# Access Compliance Report

## Public Rights-of-Way

### (Curb Ramps)

Intersection ID: 30441	Main Street: ELM_BEND_DR	Cross Street: CADENCE_CT	Location: NW
ADA ID: B58268538D45	Ramp Type: PerpDiag	Initial Pass/Fail: Fail	Overall Compliance: No
Severity Score: 10			
Codes/Mitigation Info/Possible Solution		Field Measurements/Component Compliance

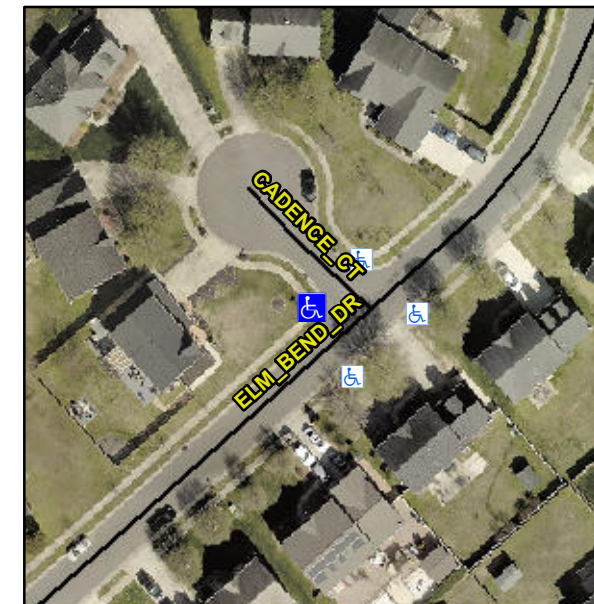
**R304.5.1, R304.5.3**

Compliance	Description	Data	Compliance	Description	Data
N/A	Ramp Length (in)	46.0	Yes	Ramp Slope (%)	7.4
No	Ramp Width (in)	46.5	No	Ramp XSlope (%)	2.3
N/A	Flare Type LT	N/A	N/A	Flare Type RT	N/A
N/A	Flare Slope LT (%)	N/A	N/A	Flare Slope RT (%)	N/A
N/A	Flare Traversable LT?	N/A	N/A	Flare Traversable RT?	N/A
N/A	Landing Length (in)	N/A	N/A	DWS Provided?	N/A
N/A	Landing Width (in)	N/A	N/A	DWS Contrast?	N/A
N/A	Landing Slope (%)	N/A	N/A	DWS Length (in)	N/A
N/A	Landing X Slope (%)	N/A	N/A	DWS Full Width?	N/A
N/A	Landing Curb? (Y/N)	N/A	N/A	DWS Offset (in)	N/A
N/A	Shared Landing?	N/A			
N/A	Gutter Ponding?	N/A	N/A	Gutter Slope (%)	N/A
N/A	Gutter Lip Ht (in)	N/A	N/A	Gutter X Slope (%)	N/A
N/A	Painted X Walk1?	No	N/A	Painted X Walk2?	No
	X Walk 1 Direction	To SE		X Walk 2 Direction	To NE
N/A	X Walk 1 Width (in)	N/A	N/A	X Walk 2 Width (in)	N/A
	X Walk 1 Slope (%)	3.5		X Walk 2 Slope (%)	1.9
	X Walk 1 X Slope (%)	1.3		X Walk 2 X Slope (%)	2.0

**Remove & Replace Curb Ramp With Two New Directional Ramps or Equivalent.**
